receive\_DME\_active in
DELIMITER WAIT state of
Figure 98-9 Receive state diagram

#### Overview

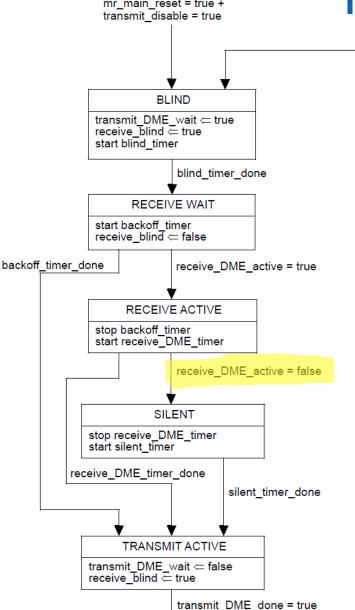
- DELIMITER WAIT state is entered after successful completion of reception of DME page from the link partner (condition detect\_mv\_end = true).
- No DME page reception is ongoing in DELIMITER WAIT
  - receive\_DME\_active should be assigned to false
  - But Figure 98-9 currently shows it as assigned to true
- Description of variable from subclause 98.5.1:

- Auto-Negotiation (i.e. Arbitration state diagram) will then proceed to completion quickly.
- Issue with receive\_DME\_active in DELIMITER WAIT means that Half-duplex state diagram and Receive state diagram do not remain in sync.

- Transition from RECEIVE WAIT to RECEIVE ACTIVE state occurs on receive\_DME\_active = true, but the Receive state diagram is holding this at true, so this transition does not occur with start of DME page reception (detect\_mv\_start in Receive state diagram).

- Lack of synchronization can give rise to DME page collision:
  - A PHY might commence DME page transmission before ongoing reception of a DME page from the link partner has completed.

- The link partner might commence DME page transmission before ongoing local DME page transmission has completed.
- DME page collision will likely provoke rx\_wait\_timer\_done (in Receive state diagram):

- Causes transition back to IDLE, assertion of an\_receive\_idle = true, and Arbitration transition back to TRANSMIT DISABLE (restart of Auto-Negotiation).
